STAFF REPORT
COMMUNITY DEVELOPMENT DEPARTMENT

SUBJECT: FP-2020-0003
Quartet Northeast No. 1

Final plat consisting of 72 buildable lots & 11 common lots on 26.4 acres of land in the R-4 zoning district.

D. Common Driveway Exhibits

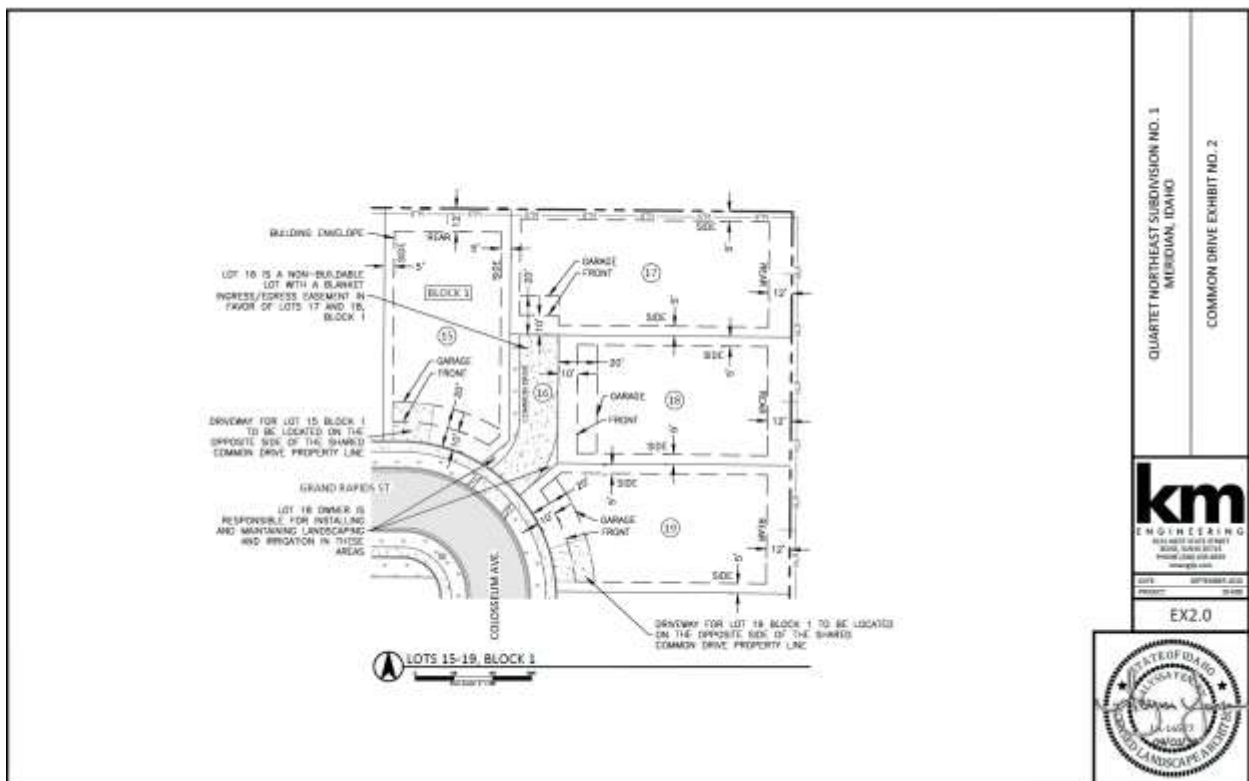
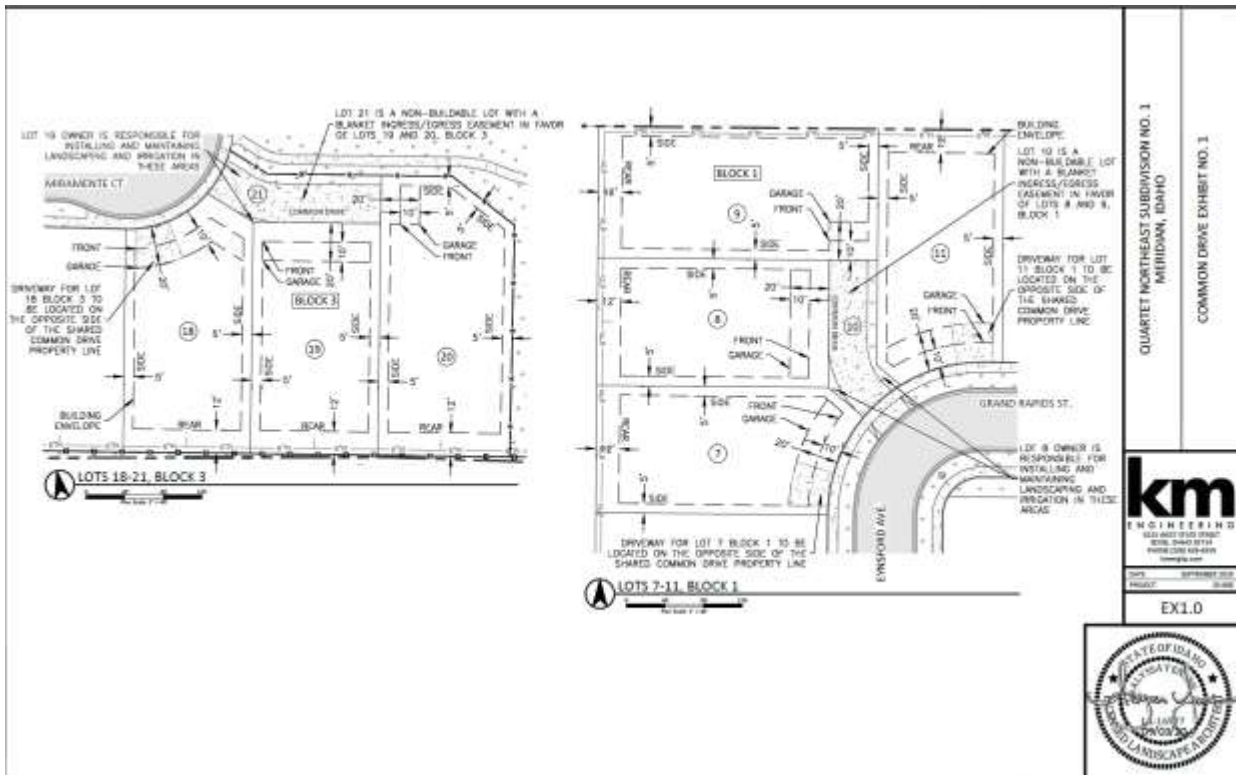
- c. Depict the location of the swimming pool and children's play equipment on Lot 9, Block 4; include a detail of the play equipment.
6. Construction of the common driveways on Lots 10 and 16, Block 1, and Lot 21, Block 3 shall comply with the standards listed in UDC 11-6C-3D and with the exhibits in Section V.D.
